Remarks

II. Drawings

Fig. 4A (Prior Art)

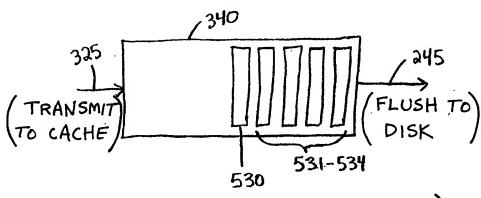
The drawings have been objected to under 37 CFR 1.83(a) for allegedly not showing every feature of the invention specified in the claims. The Examiner alleged that features of independent claims 7 and 54 are not shown in the drawings.

Figures 4C and 6A-6D have been objected to because they contain unlabeled direction arrows. In the replacement drawings, Figs. 4A-4C and Figs. 6A-6D have been amended. In particular, the direction arrows in Figs. 4A-4C and in Figs. 6A-6D have been labeled. The direction arrow to the left of the "cache 340" is labeled "transmit to cache 325." The direction arrow to the right of the "cache 340" is labeled "flush to disk 245." Support for these

It is also noted that in Fig. 4A, as originally filed, the direction arrow to the left of the "cache 340" was labeled with a reference number "325," and the direction arrow to the right of the "cache 340" was labeled with a reference number "245." In the amended figures, these reference numbers have been added to each of Figs. 4B-4C and 6A-6D, as well. Each of Figs. 4B-4C and 6A-6D depicts the cache 340; therefore, no new matter has been added by these amendments.

Claims 7 and 54 have been amended as indicated above. Figs. 4A-4C and Figs. 6A-6D have also been amended and now show each limitation of amended claims 7 and 54.

Annotated marked up drawings for Figs. 4A-4C and 6A-6D (labeled "Annotated Sheets") are enclosed. Replacement drawings for Figs. 4A-4C and 6A-6D (labeled "Replacement Sheets") are also enclosed.
